Project: Microboone PMT to Laser PS Interlock System

Doc. No: B060514PMT_Laser_Intlk

Laser Interlock Chassis

Modifications since ORC review

DIN-Header Adapter

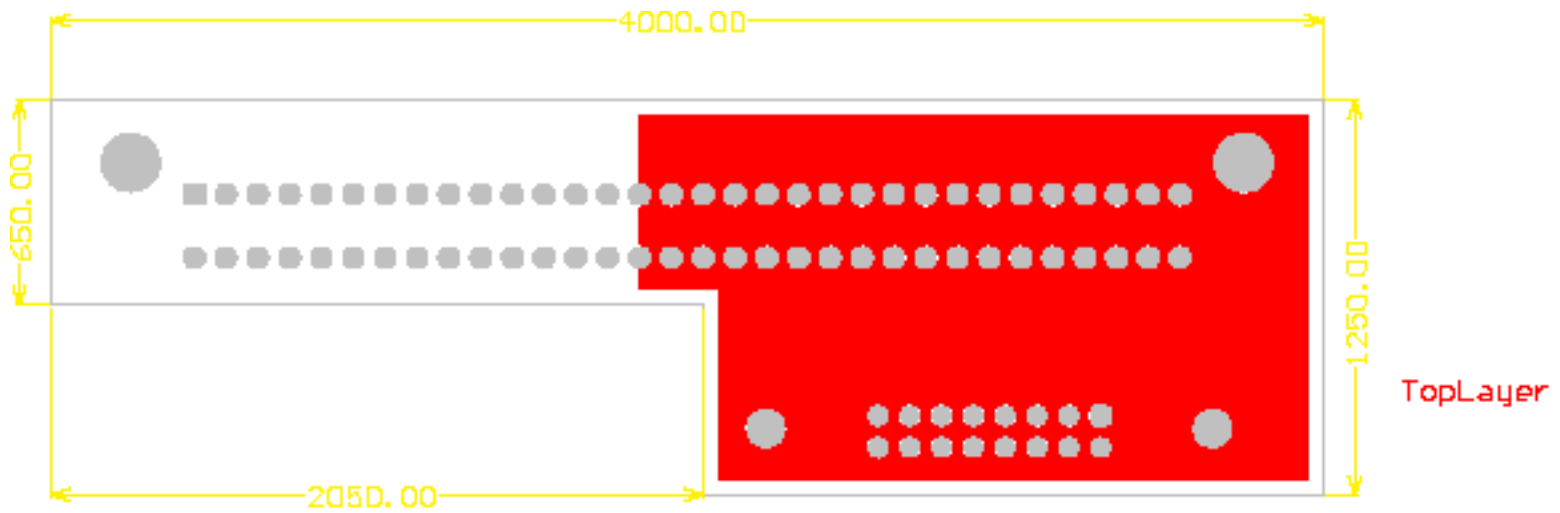
NOTE: Because we are mating with pins on the back plane the order of the pins will be reversed.

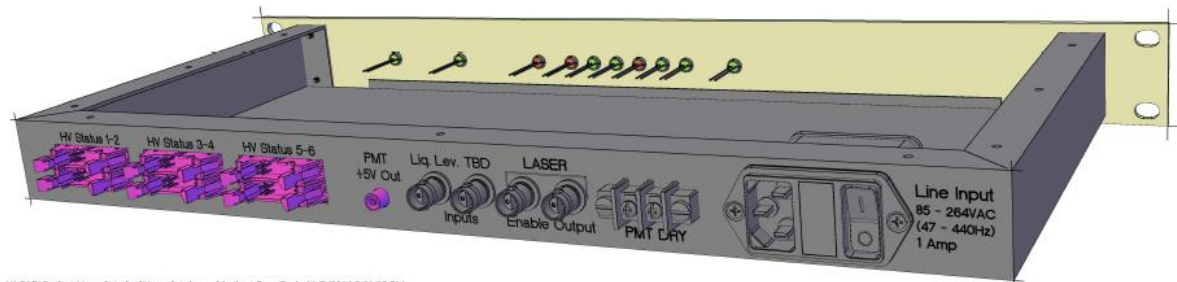
-
-
- A 16 conductor ribbon cable is needed to connect between the HV crate and the Laser Interlock chassis.
 - Five (5) cables will be needed.
 - A shorting connector is needed to by-pass the extra input.

One end of this cable needs to be flipped to correct an error on the chassis PCB.

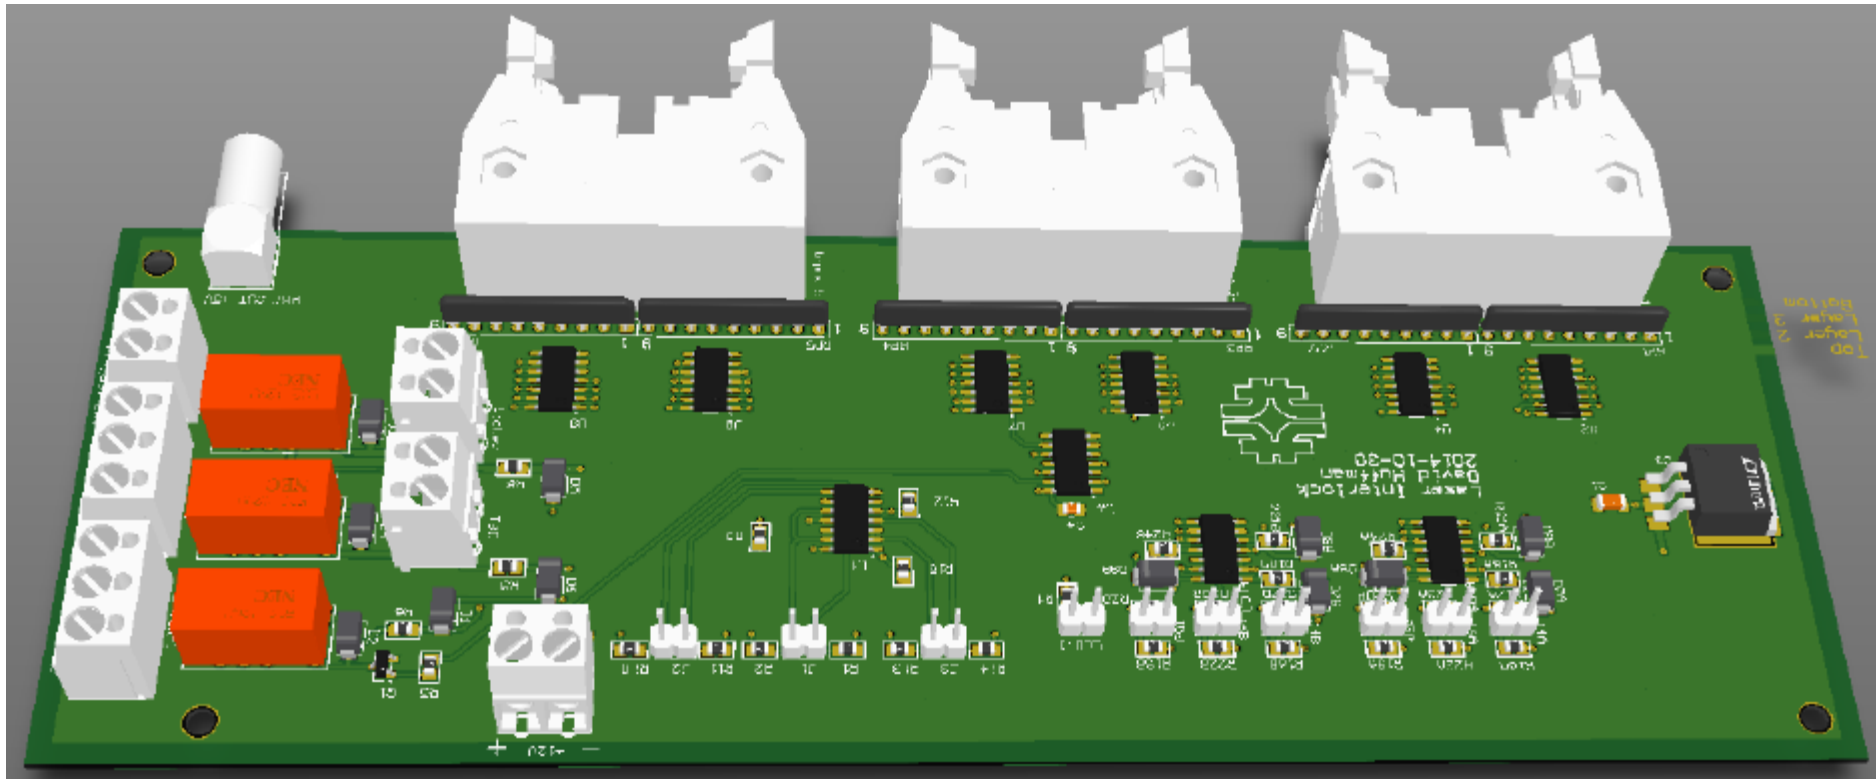
-
-
- Powering the chassis revealed only one LED lit, +5V indicator.
 - Checking the PCB project I found the diode silkscreen is labeled wrong.
 - Corrected library and will have to **reverse all the diodes**.
 - Hopefully none of the components are fried.
 - Changed the diodes, no better, something else is wrong.
 - Seems like the LED readout is drawing too much current.
 - Not the case! With or without the LED attached the voltages are the same.

- NOTE: the resistors R6,8 & 9 are too small. They keep the relay on because the coil is 1440 Ohm.
 - Will see about raising the value to let the relay operate properly.

- MC14069 chips are not working as expected. The output current is <2mA
 - Ordering SN74LV14APWR SOIC-14 that will have enough drive current.
 - **Changed MC14069 with SN74LV14APWR**

- Change the input resistors that go to the LED circuit to minimize loading.
 - Thinking 15K Ohm will be about right.

- DIN-Header cards have a problem with the DIN connector not close enough to the board edge.
 - The boards will need to be cut or sanded to remove material up to the silkscreen line.

- Replaced the LED drivers and things look okay except the regulator is getting very hot.

-
-
- Error on the heatsinking of the 12V to 5V regulator. The tab copper is too small. Need to add an external heatsink.
 - Will also lower the current drive of the LEDs. The design is for 10mA will see if 5mA is better.
 - This will lower the power from 700mW to 350mW.
 - Okay there was a SNAFU with the hex inverters. The outputs of a 74lv14APWR can sink and source 20mA.
 - This bypasses the current limiting resistors and draws more current than expected.
 - I added a series resistor (470 Ohm) to limit the LED current.
 - Removed R1-3, R10-12, R13-15 and R16-24 both A&B sections 24 total

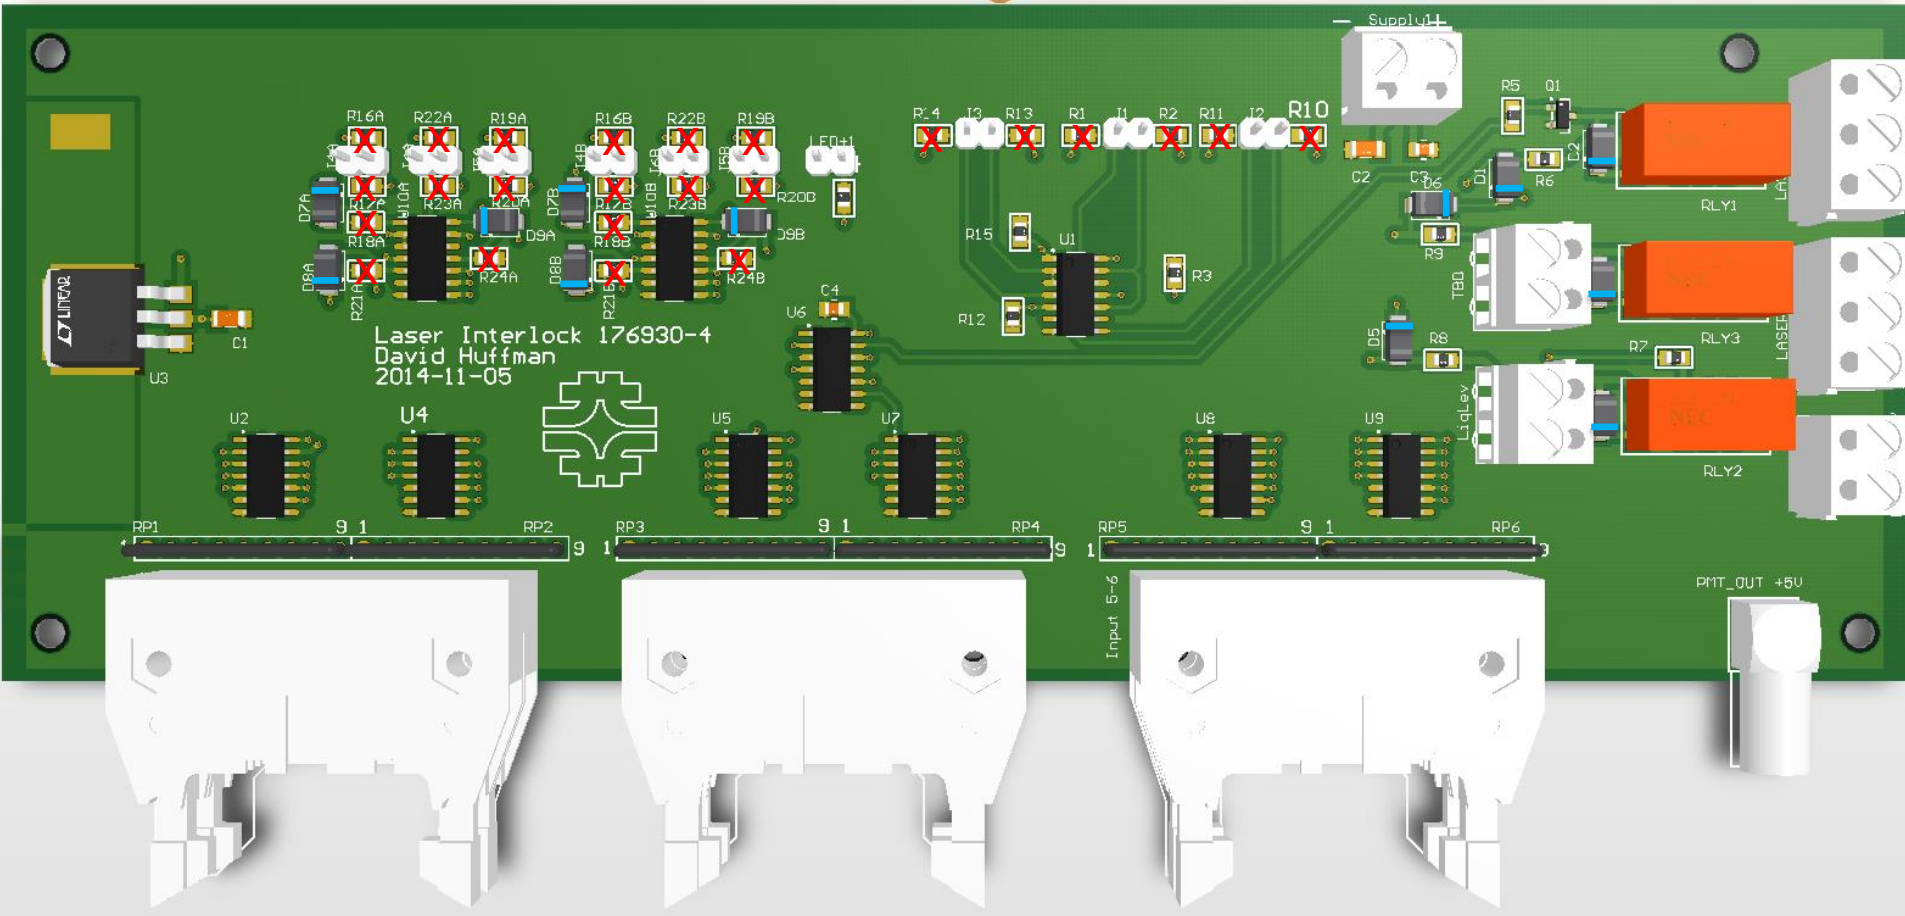
- Discovered the condo connectors have a bad footprint. Rows are swapped causing the signal from the MPod to be shorted to ground.
 - We will flip one of the header connectors to fix the problem. We can do this because the order of the signals is unimportant. Need a note that indicated the cables are special.

- Fixed the library part but did not update the PCB.

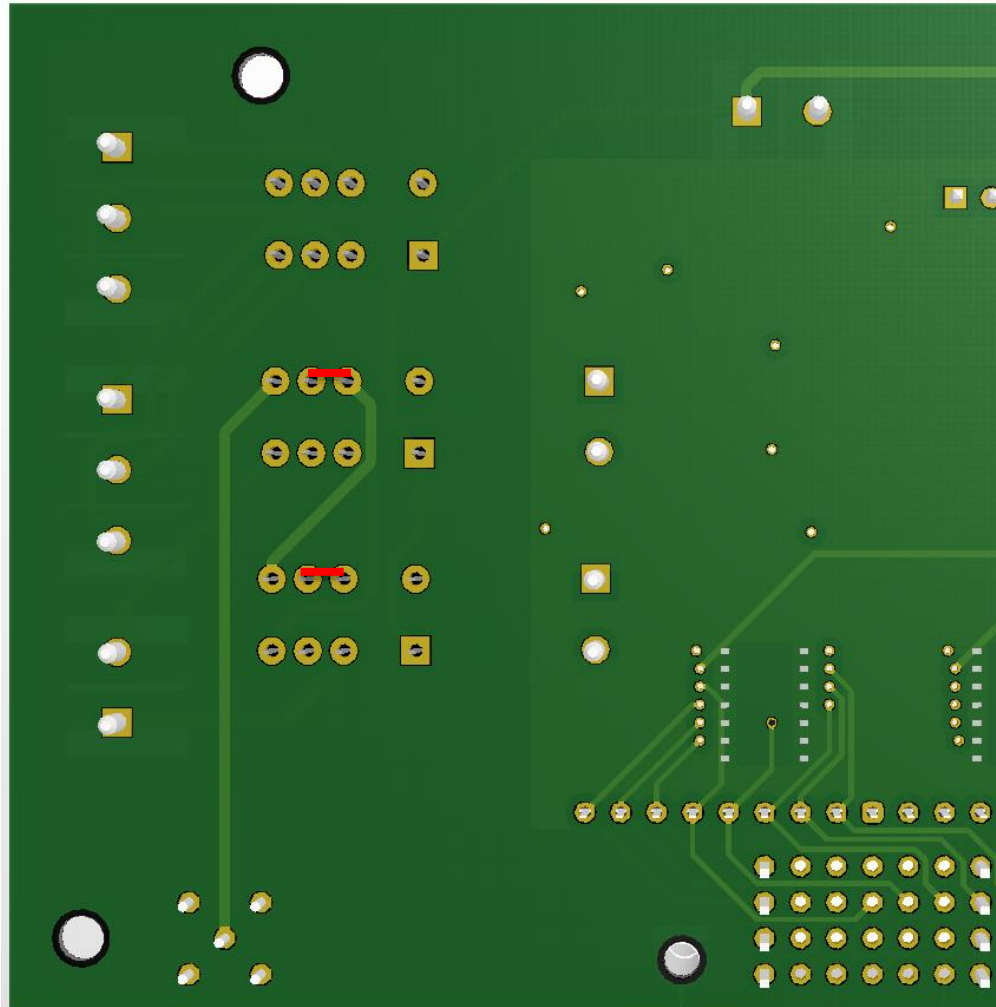
- 12/4/2014 11:22:52 AM
 - errors! Found two inputs on the final OR gate tied high. They should have been pulled low. Lifted the pins and tied it to its neighbor(4&5)(9&10).
 - The outputs of the relays are incorrect. The Laser outputs were moved to the NO NC terminals. The PMT outputs +5 and dry contacts are wrong.
 - The relay footprint is in question...
 - Footprint was wrong. Changed the library but did not update the project.
 - Added a jumper on the bottom of the board to fix the problem.
 - Changed R7, the PMT_OUT +5V signal, to 200 Ohms. This gives the maximum current and power if the output is shorted.
 - Replaced R7 with 0 Ohm resistor. This relies on the LDO regulator's over current and temperature protection. Smallest trace is 15mils. with 1/2oz copper there is 10sq mils, IPC table shows outside trace good for 1Amp with 22°C temperature rise.

Top View

Do Not Load Reverse Direction

Bottom Correction Wires
